**Rationale for Route Change of NG Pipeline from FSRT to Old Harbour  
as part of the  
New Fortress Energy Marine Terminal and Pipeline Project  
Old Harbour, St. Catherine**

**Original EIA: September 2016  
Route Change and Other Amendments: December 2017**

**Evaluation prepared by:**

**January 2018**

**Figure 4. Proposed new route and New location of FSRT compared to originally permitted infrastructure.**

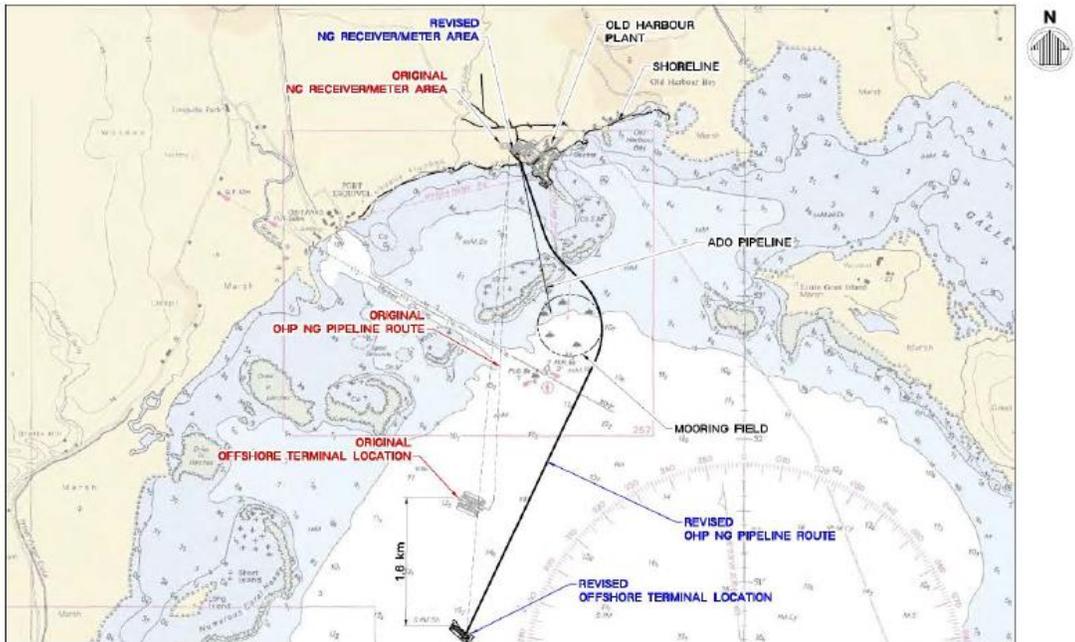
*“Both pipelines will be along the same route reducing the overall footprint of the project.”<sup>4</sup>*

The existing ADO pipeline goes in a different line, at least according to the figure provided in the Rationale Report, and the new ADO pipeline has been dropped from this project as part of the proposed amendments.<sup>5</sup>
